TEAL Electronics Corporation 10350 Sorrento Valley Road San Diego, CA 92121 (800) 888-TEAL (8325)
Technical Service Bulletin 102109-1	
Author: Robert Gregg	Date Issued: 10/21/2009
Filename & Path: G:\GROUP\SALES\Product Support\Technical Service Bulletins\TSB102109-1.pdf

Purpose: To replace power supply mounting screws that are too long that could possibly cause the internal shorting to ground of PS1 and/or PS2 .

Scope: All XGD PDU's (TEAL P/N 6600003, GE P/N 5140621) manufactured between 12/14/2007 & 8/7/2008. 25 PDU's are affected by this TSB.

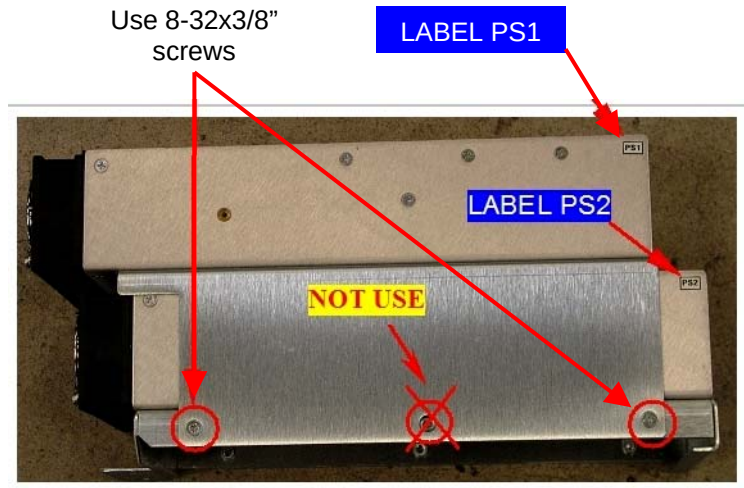
5. Disassemble the power supply mounting brackets and remove the power supplies from the mounting brackets (Discard the existing screws (8-32x3/8") used to mount the power supplies to the mounting brackets)

6. Mount the power supplies to the two mounting brackets using a small drop of Loc-tite applied to the supplied 8-32x1/4" screws. Torque to 16 in-lbs. Make sure the power supply labeled PS1 is mounted to the upper mounting bracket (P/N 0590905) and the power supply marked PS2 is mounted to the lower bracket (P/N 0590902)

Use 8-32x1/4" screws

Caution: Do not use the 8-32x3/8" screws to mount the power supplies to the mounting bracket

Use 8-32x1/4" screws

7. Apply the screw torque labels (1 each) to the bottom center of each of the power supply mounting brackets
